# **Accessibility Survey**

# 4th Street - Paramount Boulevard to Downey Avenue

Date of Inspection 7/21/2017

**Disability Access Consultants**

# Change in Level East of La Reina Avenue @ 33.943384423046, -118.132351934910

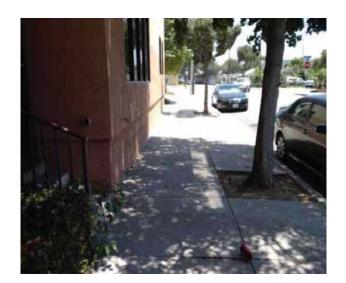
There is a change in elevation greater than recommended value.

On-Site Finding 0.50 inches

Ensure that the change in elevation is within the recommended value.

Recommendation Up to 0.25 inches

# Change in Level East of La Reina Avenue @ 33.943532394264, -118.132606744766

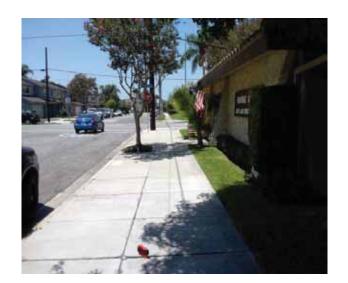
There is a change in elevation greater than recommended value.

On-Site Finding 0.75 inches

Ensure that the change in elevation is within the recommended value.

Recommendation Up to 0.25 inches

# Change in Level East of Paramount Boulevard @ 33.945285777986, - 118.135011345148

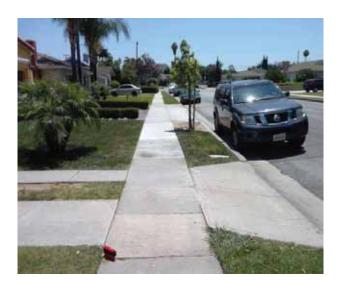
There is a change in elevation greater than recommended value.

On-Site Finding 0.50 inches

Ensure that the change in elevation is within the recommended value.

Recommendation Up to 0.25 inches

### Change in Level West of La Reina Avenue @ 33.944396852554, -118.133959919214

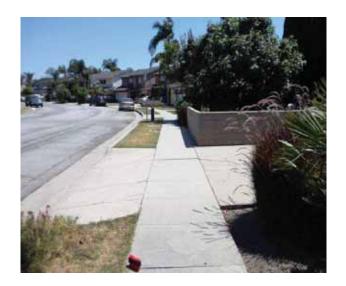
There is a change in elevation greater than recommended value.

On-Site Finding 0.37 inches

Ensure that the change in elevation is within the recommended value.

Recommendation Up to 0.25 inches

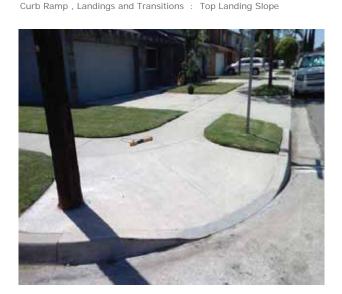
The slope at the top landing is greater than allowed.

On-Site Finding 2.50 percent

Provide a top landing surface that does not exceed the maximum slope and cross slope. Provide a sufficient maneuvering clearance that does not accumulate water.

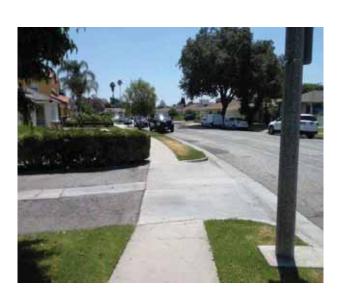
There are no detectable warnings where the pedestrian route crosses vehicular traffic.

On-Site Finding Not Found

Provide detectable warnings.

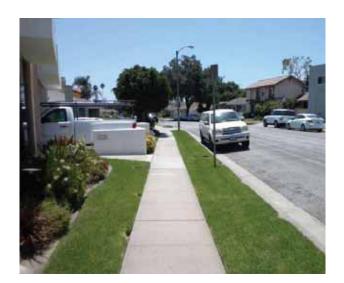
Sidewalk cross slope is not compliant.

**On-Site Finding** 7.00 percent for 95.00 feet

Repave the sidewalk surface with the recommended cross slope.

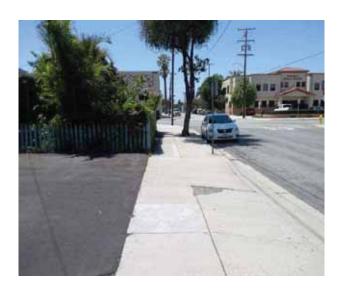
On-Site Finding Not Found

Provide detectable warnings.

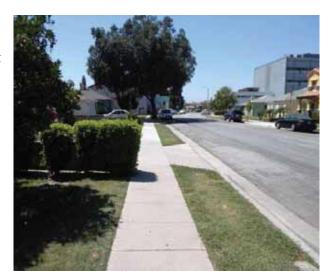
Sidewalk cross slope is not compliant.

**On-Site Finding** 4.30 percent for 143.00 feet

Repave the sidewalk surface with the recommended cross slope.

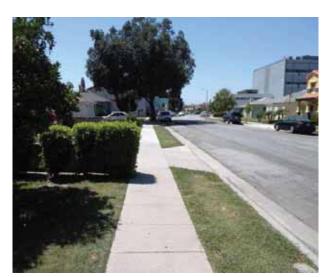
Ground surface has an opening that is not compliant.

On-Site Finding Not Compliant

Make sure that the surface opening does not allow passage of a sphere more than  $\frac{1}{2}$  inch in diameter.

# Change In Level West Of Paramount Boulevard @ 33.946916748441, - 118.138052970171

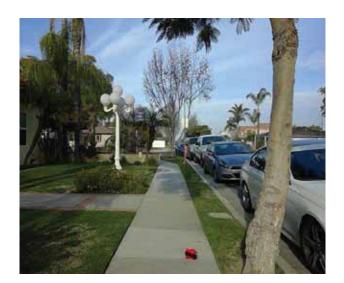
There is a change in elevation greater than recommended value.

On-Site Finding 0.75 inches

Ensure that the change in elevation is within the recommended value.

## Change In Level East Of Rives Avenue @ 33.947774497306, -118.139411509037

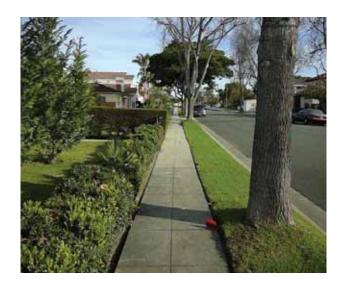
There is a change in elevation greater than recommended value.

On-Site Finding 0.37 inches

Ensure that the change in elevation is within the recommended value.

# Change In Level East Of Smallwood Avenue @ 33.946453938718, - 118.136858046055

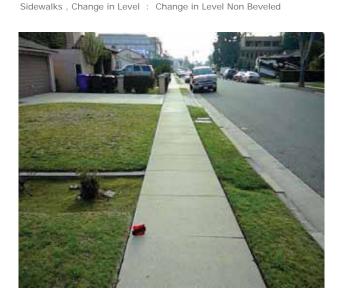
There is a change in elevation greater than recommended value.

On-Site Finding 0.37 inches

Ensure that the change in elevation is within the recommended value.

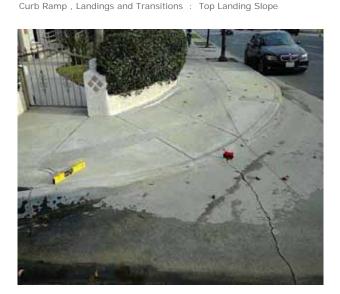
The slope at the top landing is greater than allowed.

On-Site Finding 3.20 percent

Provide a top landing surface that does not exceed the maximum slope and cross slope. Provide a sufficient maneuvering clearance that does not accumulate water.

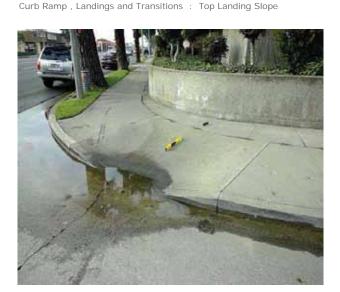
The slope at the top landing is greater than allowed.

On-Site Finding 4.60 percent

Provide a top landing surface that does not exceed the maximum slope and cross slope. Provide a sufficient maneuvering clearance that does not accumulate water.
